SUBJECT: NEW ORCHARD FARM ELEMENTARY SCHOOL
ORCHARD FARM R-V SCHOOL DISTRICT
ST. CHARLES, MISSOURI
PROJECT # 23-09B

ADDENDUM NO. 1 PROJECT 23-09B
ORCHARD FARM R-V SCHOOL DISTRICT
NEW ELEMENTARY SCHOOL
ST. CHARLES, MISSOURI JULY 23, 2024

The drawings and specifications are hereby supplemented and amended to include the following particulars:

DRAWN BY SWR
CHECKED BY CLH
SHEET NO.
C3.00
SD-31

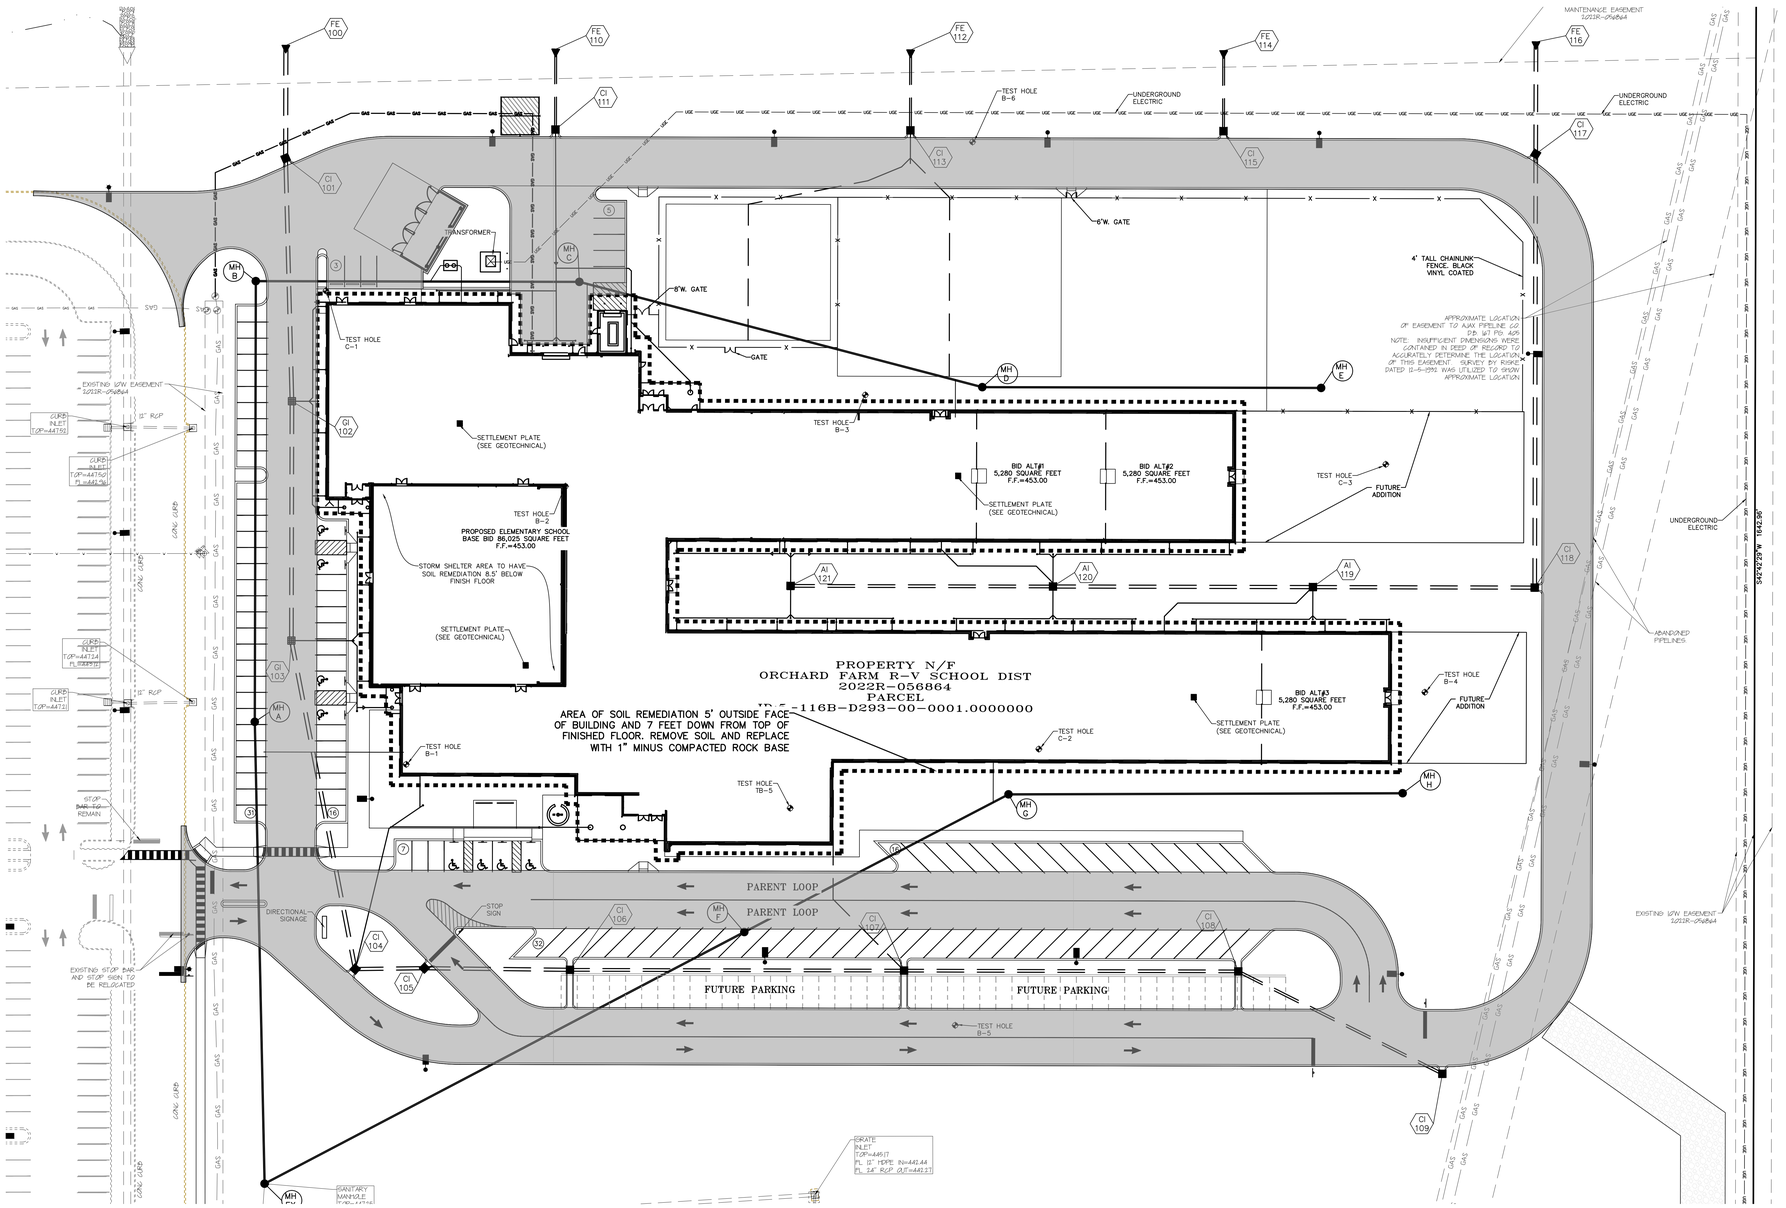
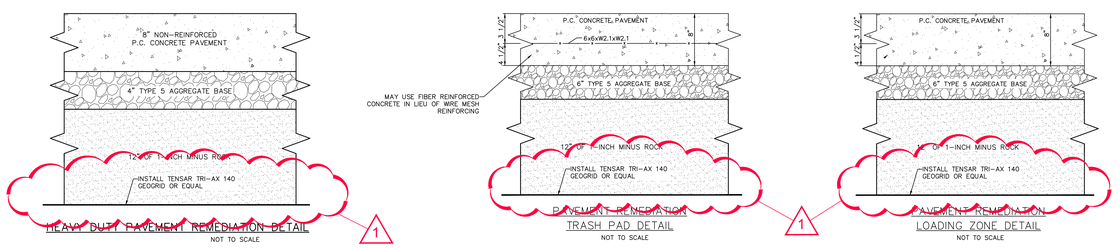
A. **"ADD"** Supplementary Drawing No. SD 31, dated July 23, 2024 included with this Addendum, and hereby made a part of the Contract Documents that shows geogrid fabric added to remediation details.

DRAWN BY SWR
CHECKED BY CLH
SHEET NO.
C6.00
SD-35

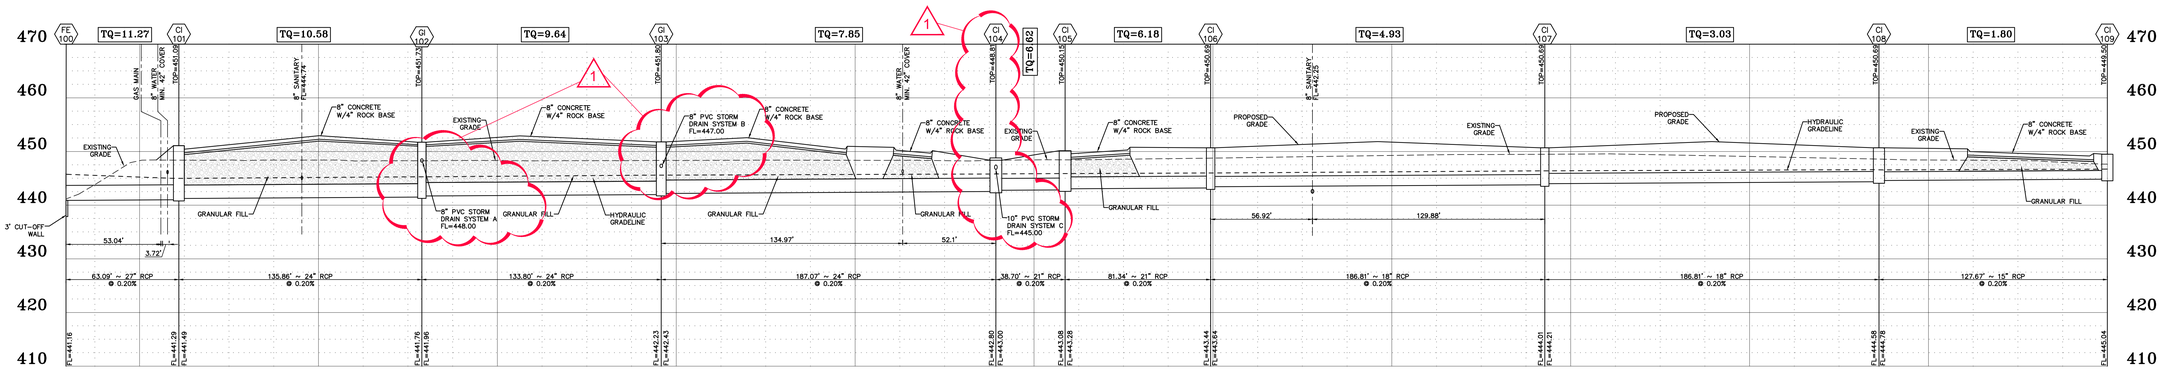
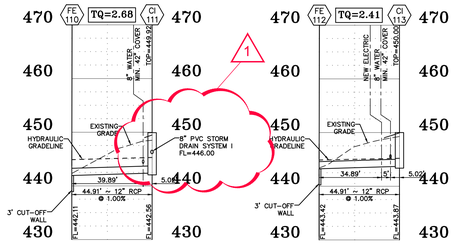
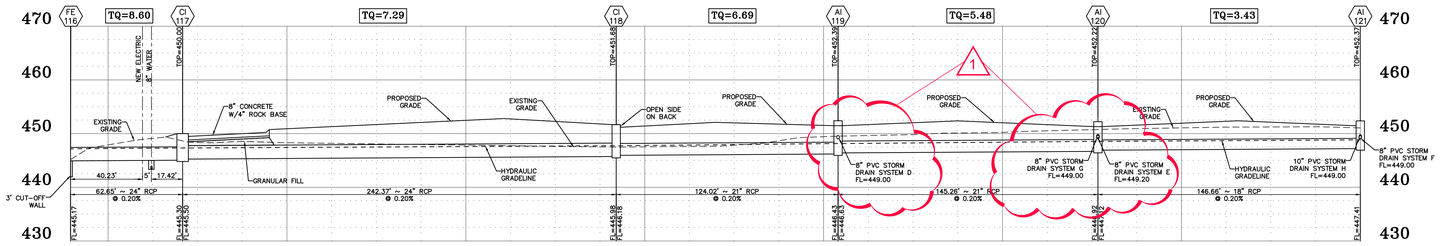
A. **"ADD"** Supplementary Drawing No. SD 35, dated July 23, 2024 included with this Addendum, and hereby made a part of the Contract Documents that shows downspout connection elevations added on storm sewer profiles.
